UNITED STATES PATENT AND TRADEMARK OFFICE

| APPLICATION NO. | FILING DATE | FIRST NAMED INVENTOR | ATTORNEY DOCKET NO. | CONFIRMATION NO. |
|-----------------|-------------|----------------------|---------------------|------------------|
| 10/733,321 | 12/12/2003 | Dennis Erickson | S758 0002/TAR | 9077 |

DETAILED ACTION

**Fig. 9**

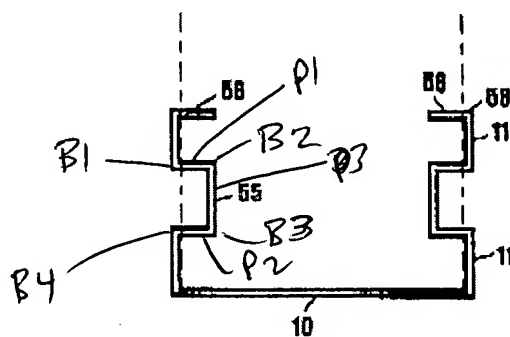
edge thereof with three bends. “STEELER INC. – Deflection Track” discloses the basic claimed track except for the particulars of the deformable portion. SUROWIECKI, figure 9 teaches the use of a track (10) wherein the deformable portion includes at least four bends (B1-4). It would have been obvious to one having ordinary skill in the art at the

time the invention was made to provide the track of "STEELER INC. – Deflection Track" with the four bend portion of SUROWIECKI in order to provide the track with more versatility in bending. Regarding claims 2,12,21,41,45,48, the deformable portion (D) consists of a unitary piece of material and is resiliently deformable using one or more legs. In reference to claims 3,5,5,7,18,34,43,44,47,49,50-55, the deformable portion (D) allows the track to compress in the longitudinal direction and expand orthogonally. In regards to the angles formed in the deformable portion, it would have been obvious to one having ordinary skill in the art at the time the invention was made to select an angle suitable for the use intended as an obvious matter of design choice. For instance, in areas where earthquakes are common perhaps an angle that is wider to compensate for the extra forces imposed thereon would be appropriate. Regarding claims 4,13,14,16,22-26,29,30, the deformable portion (D), as modified by SUROWIECKI has

EXAMINER'S ATTACHMENT

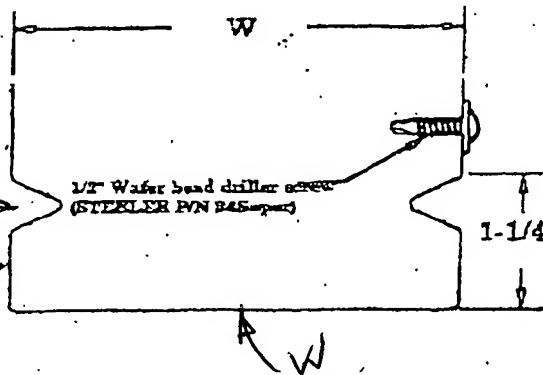
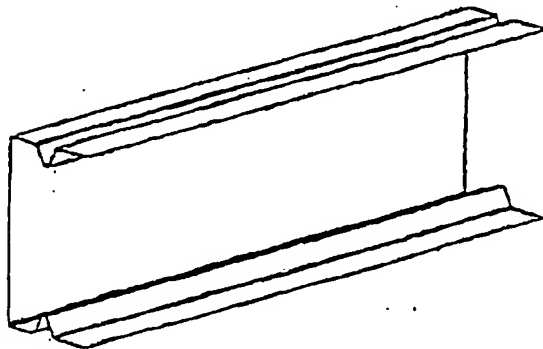
Claims 1-7,12-14,16,18,21-26,29,30,41,43-45,47-55 are rejected under 35 U.S.C. 103(a) as being unpatentable over "STEELER INC. – Deflection Track" in view of US Patent #6,374,558 to SUROWIECKI. In reference to claims 1,43,47,53-55, "STEELER INC. – Deflection Track" discloses a track including a web (W) and one or more deformable legs (L), see attachment, having a deformable portion (D) at a distal

a first angled portion (P1), a second angled portion (P2) and a central portion (CP) between the four bends (B1-4), and a flat portion FP) between deformable portions (D) wherein the deformable portion extends outwardly of the track and the track is coupled to opposite ends of another track near the flat portions (FP).
